Board of Architectural Review

DATE: June 21, 2023
TO: Board of Architectural Review Chair and Members
THROUGH: Jason Sutphin, Community Development Division Chief *JDS*
FROM: Anna Kohlbrenner, BAR Liaison *AK*
SUBJECT: **Work Session: 10306 Eaton Place – WillowWood**

1. Case Number:	BAR-23-00041
2. Address:	10306 Eaton Place
3. Request:	Mixed-use building
4. Applicant:	Capital City Real Estate LLC
5. Applicant's Representative:	Evan Pritchard
6. Status of Representative:	Attorney
7. Zoning:	CR Commercial Retail, ACOD

1 | SOUTH ELEVATION

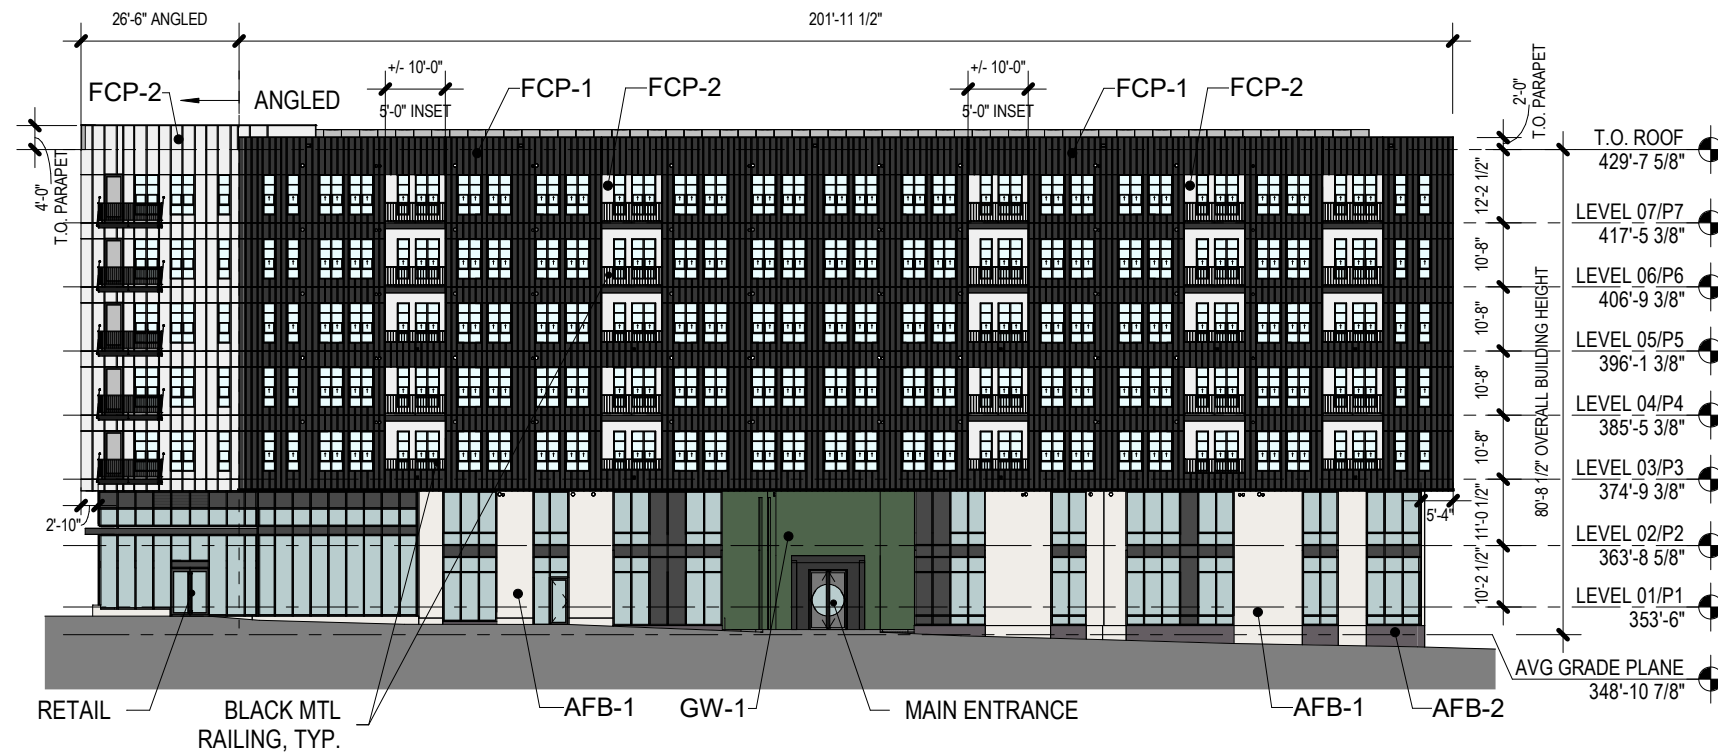
The human scale is not reinforced in this design. The building size appears overwhelming, without a change in material at the pedestrian realm. The building width along the east side is approximately 275' wall of fiber cement panel with little to no windows and a precast concrete parking garage, which does not engage pedestrians or drivers in any way. Portions of the parking garage are visible from Eaton Place. The applicant shall look at treatments to screen it. The building width along the west side is approximately 300', not including the parking garage section, which is a long wall of repetitive windows and fiber cement material and some brick from the first to second story. The western building wall shows repetitive utilitarian balconies. The building scale along Eaton place shows repetitive windows, with little character and sense of place.

Storefront is proposed on the first floor of the mixed-use building. Large amounts of glass with little variation of material does not provide a storefront module. There is no visual relief at the storefront level, as the proposed architecture appears uninviting. Changes may include fenestration changes, installation of art, or experiential elements that may include creative landscaping.

The applicant is not proposing a different foundation material on the east and west sides of the building. The 3D rendering along Eaton place does not show a different color of brick along the foundation line, but on the elevation sheets, it shows a darker brick proposed in this area. Staff recommends using separate foundation material on east and west sides as well, in addition to continuing a different color brick or material along Eaton at the foundation line.

The applicant is proposing brick on the west and south sides of the building but only up to the second floor. The east side of the building does not have brick, only fiber cement and concrete. The applicant shall add varying material bays throughout while adding more masonry material.

1 | N-S SIGHTLINE SECTION

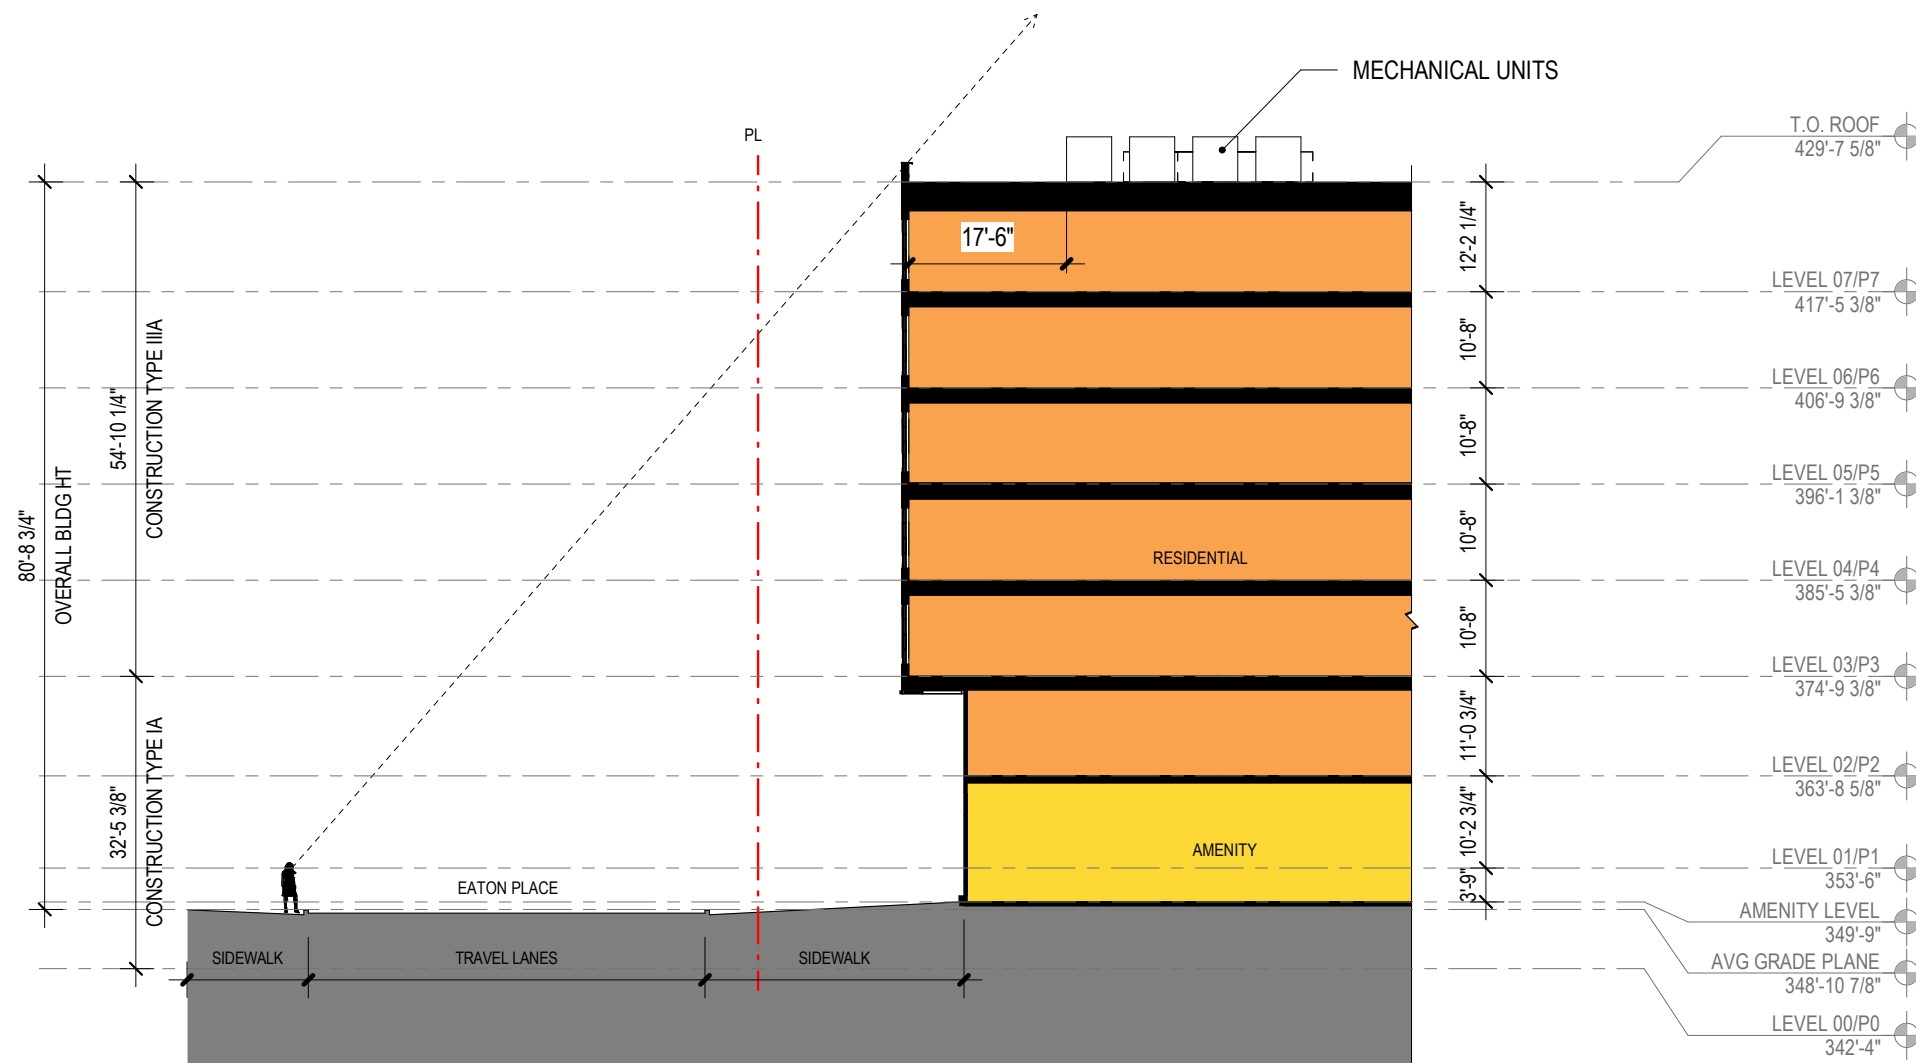
Mechanical equipment would be located on the rooftop and would not be visible, according to submitted site line diagram. Would need to be hidden from Fairfax Blvd as well, as this building adds to the skyline of Northfax.
